SERVICE PROGRAM BULLETIN

APPLICABILITY: 2022 MY WRX

NUMBER: WRA-22

SUBJECT: WRX EyeSight® Reprogramming

EyeSight® Stereo Camera Part Information:

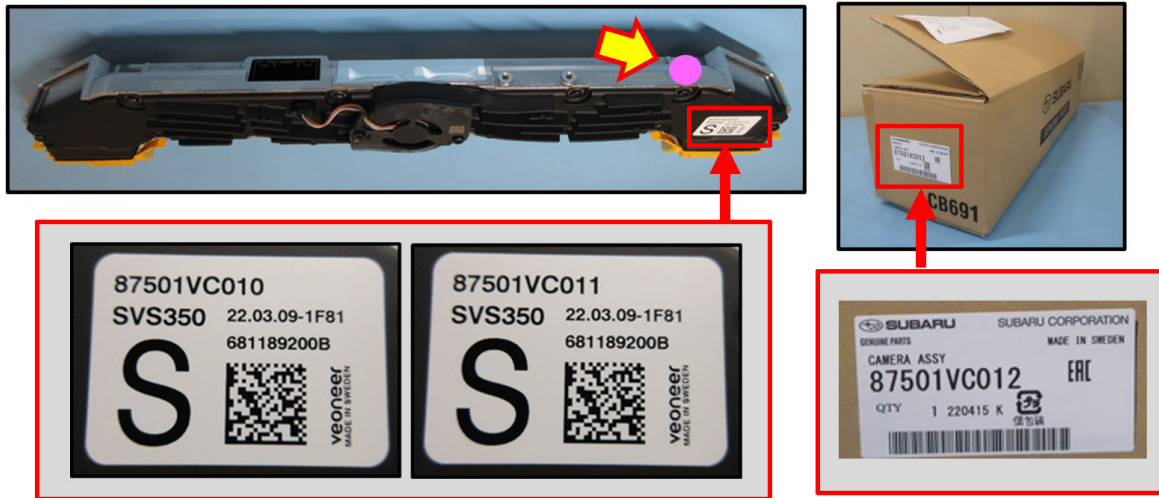
IMPORTANT: The part number labeled on the stereo camera assembly may be **87501VC010** or **87501VC011** even though the part number located on the outer box is **87501VC012**. If the part has a pink dot sticker as shown in the image below, this indicates that the software has been updated to the latest version and can be used in place of **87501VC012**.

Part Description	Part Number
CAMERA ASSY	87501VC012
